16-4-01

Modified arrangement of deck opening

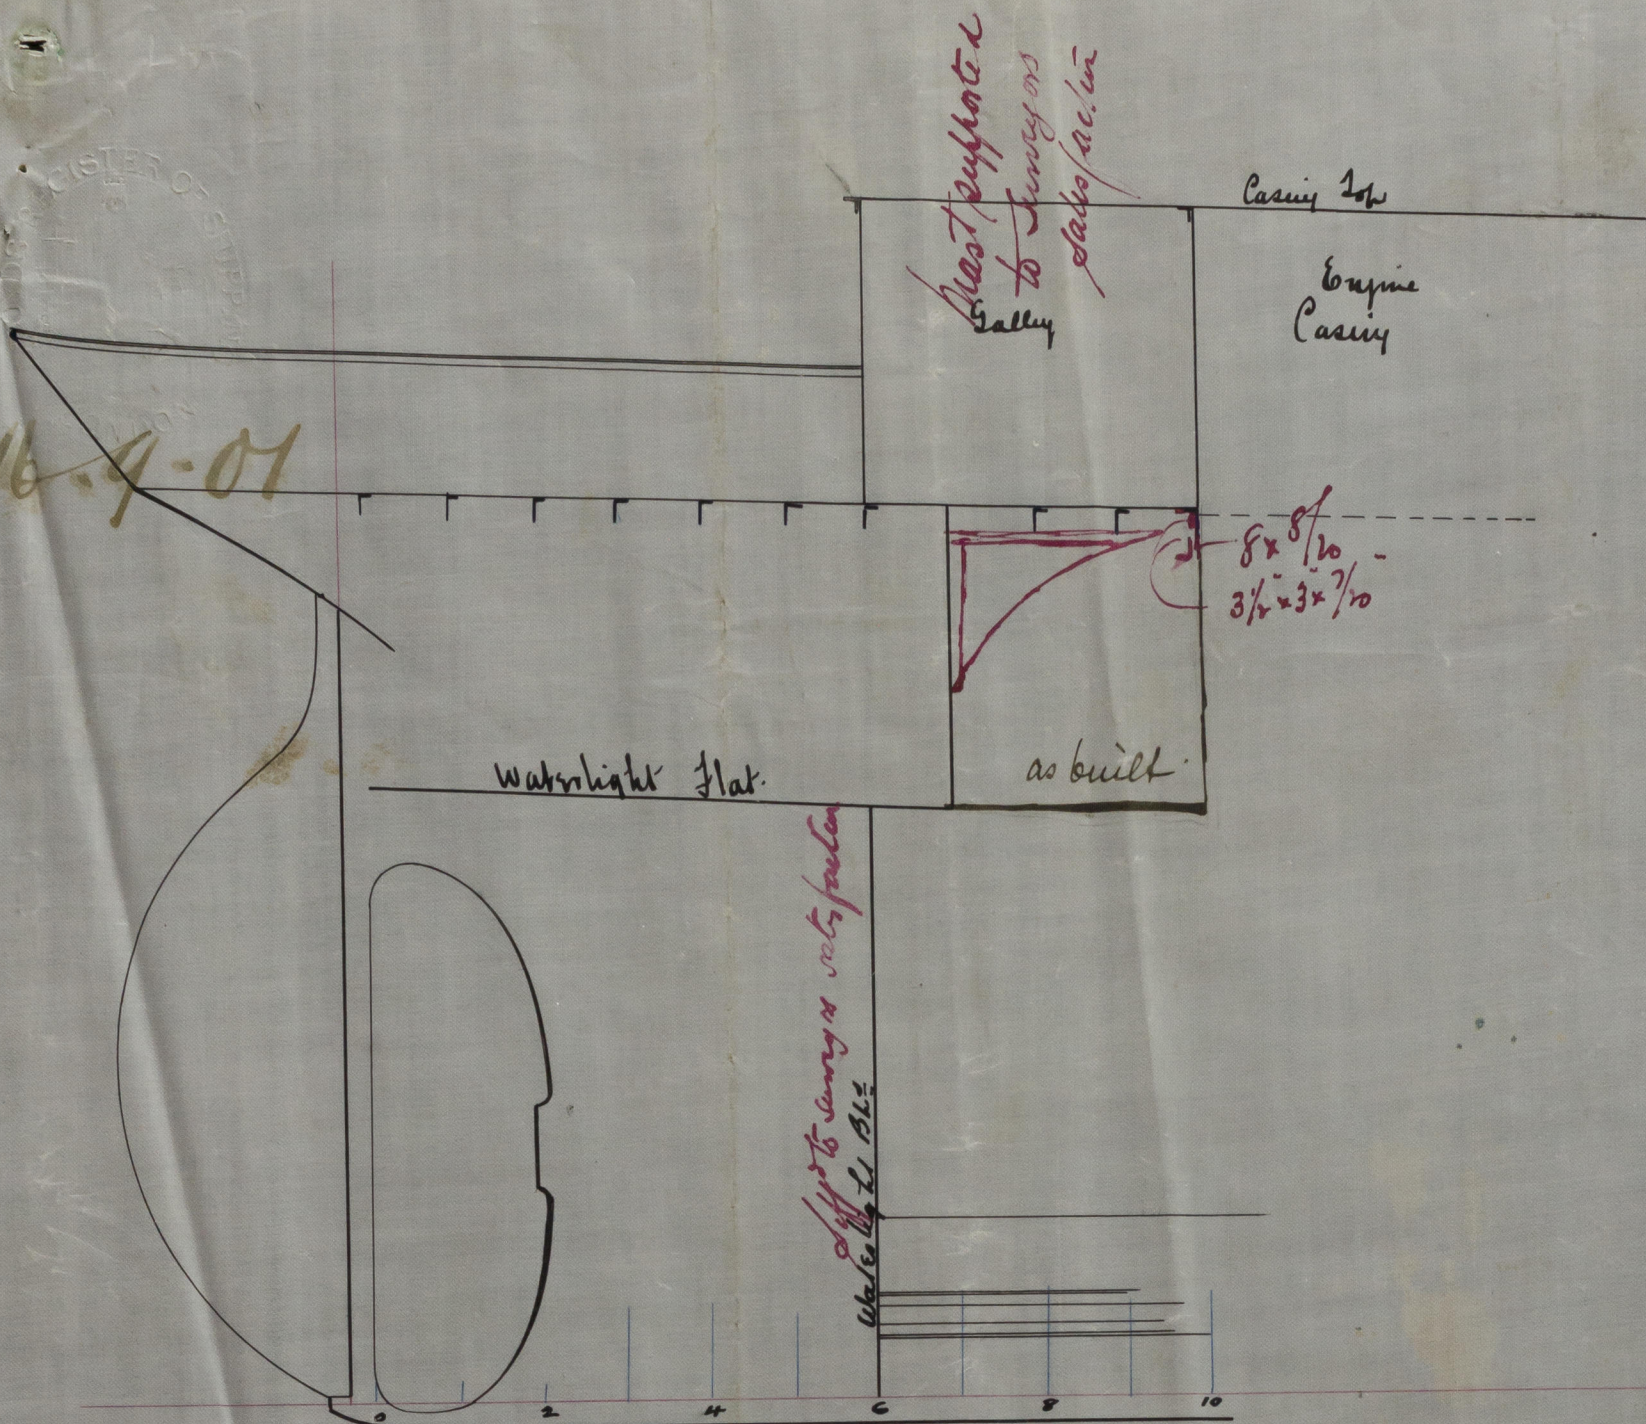
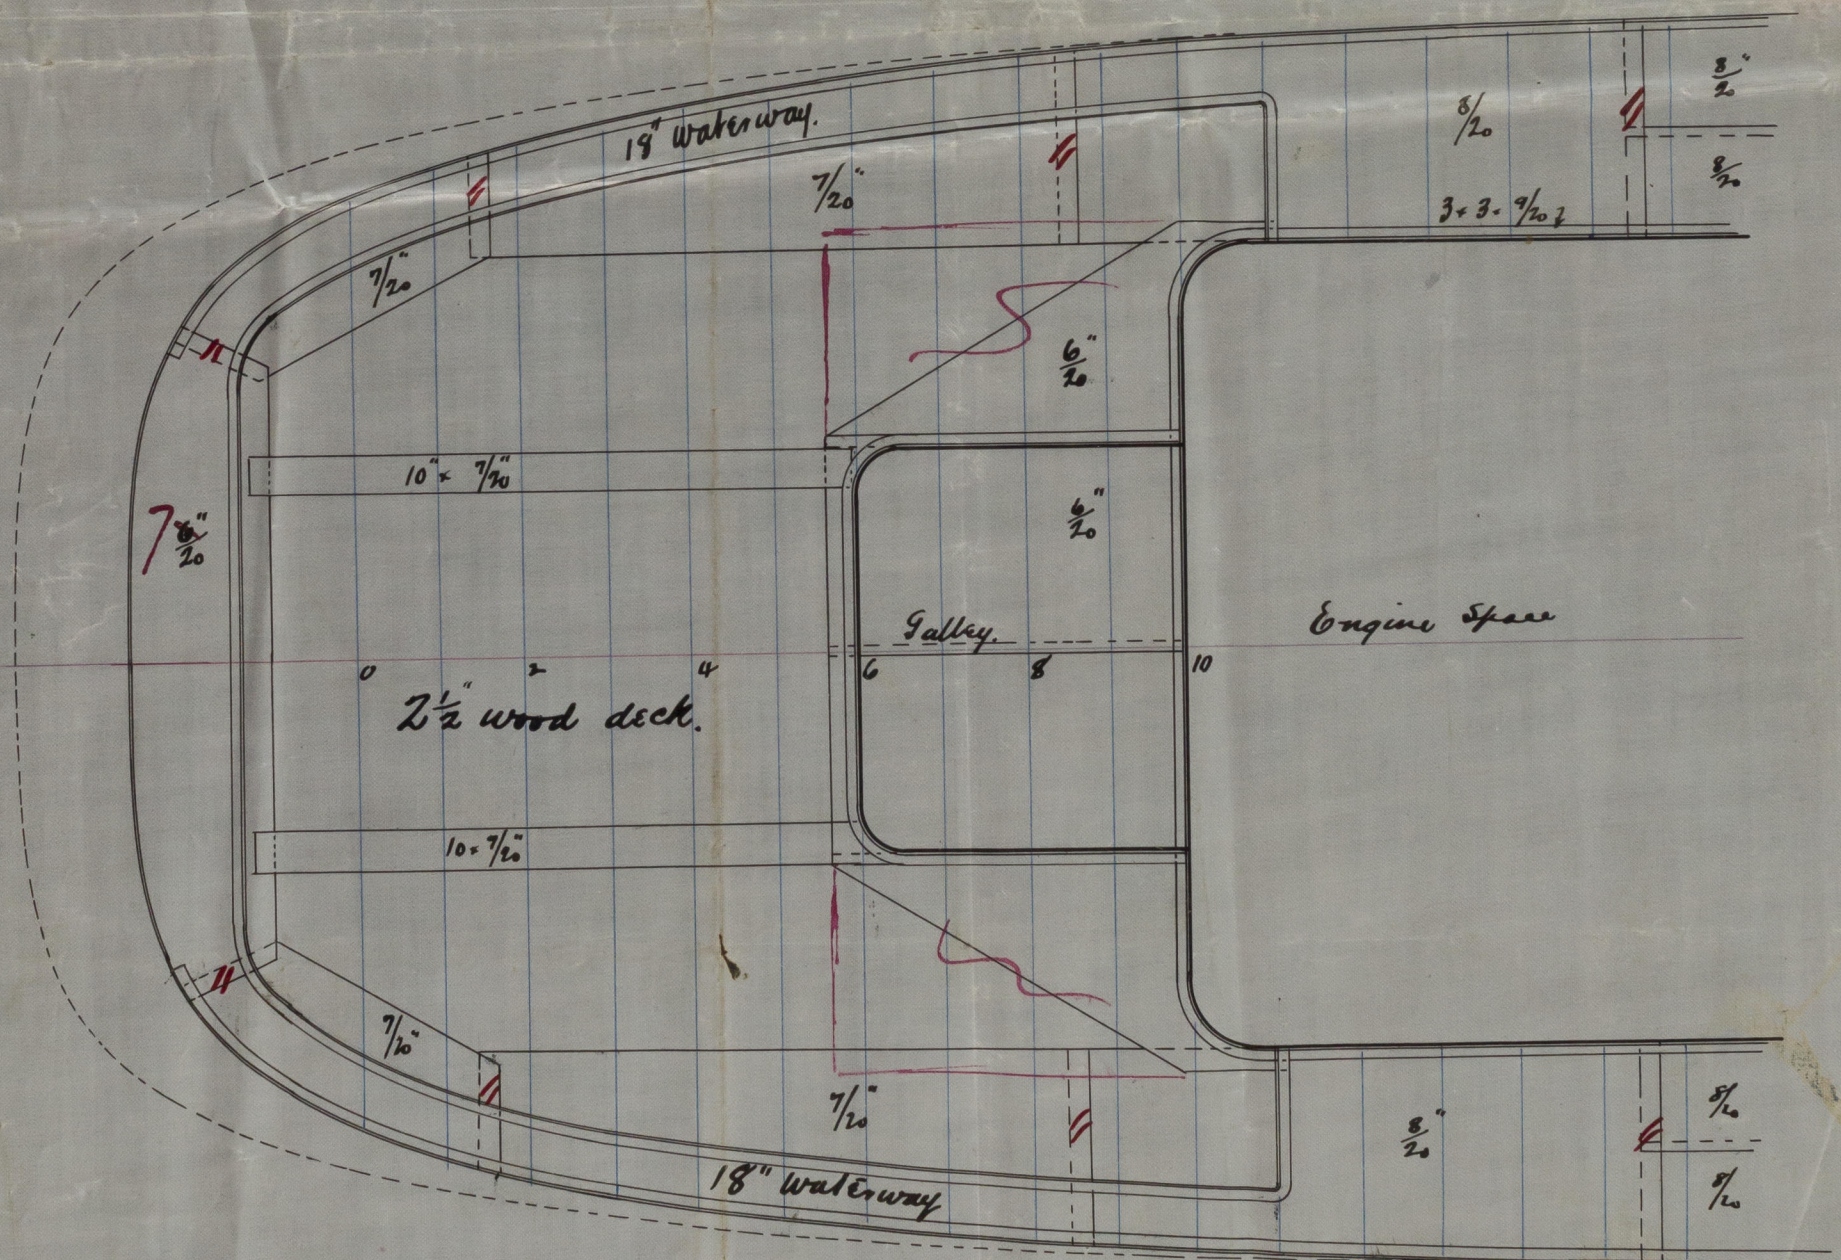
Rivets through frames
shall be drawn apart.
